## DISTRIBUTING CO., INC.

SERVICE NOTE KDK 2025A MK11

SERVICE NOTES/HINTS AND KINKS

### SERVICE NOTES/HINTS AND KINKS

Drawing #1 shows the unit as it comes from the factory. Note that the lugs on the left of the AF choke have two orange wires. One of the wires on the far left goes to the switch. The other orange wire goes to the power module. This wire will be moved to the right lug as shown in figure #2.

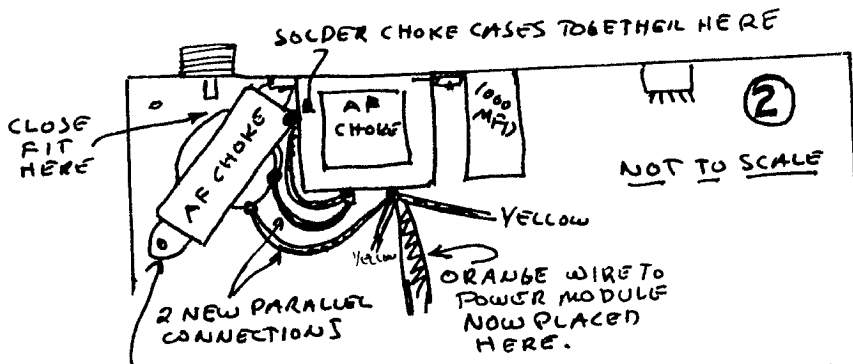
Install duplicate transformer/choke as per diagram #1 & #2 and rewire as shown. Use heavy stranded wire to wire the choke in parallel with the existing choke. Install a .068 mfd mylar capacitor at the power module and ground lug as shown in figure #3. Then check power output. Some readjustment of the high and low setting might be required.

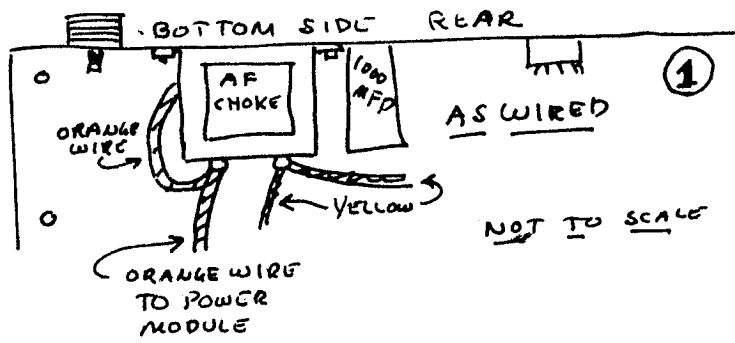
Drawing #2 The second AF choke is placed on the chassis. Rather close fit. It is suggested that the cases of the two chokes be soldered together where they touch. Scrape the enamel from the surfaces to be soldered and tin each first using a good hot iron. The mounting tab on the far left should also be cleaned and soldered first and the protruding bolt as well. Then they will solder well and hold. A longer bolt through the low pass filter unit with a nut on the end holding the new choke in place is to be preferred over soldering the tab to the bolt. Two wires, about 18 guage are now used to wire the lugs of the two chokes in parallel as per drawing. Only the orange wire from the power module is moved and is now soldered to the right lug on the original choke.

SOLDER CASE OF CHOKE TO PROTRUDING BOLT OR - USE LONGER BOLT THRU LO PASS FILTER BOARD AND PUT A NUT ON THIS END TO HOLD CASE OF CHOKE TO CHASSIS

\*BE SURE MODER STICKS TO BOLT AND CHOKE FRAME. USE FILE OR SANDPAPER TO CLEAR SURFACE BEFORE SOLDERING.
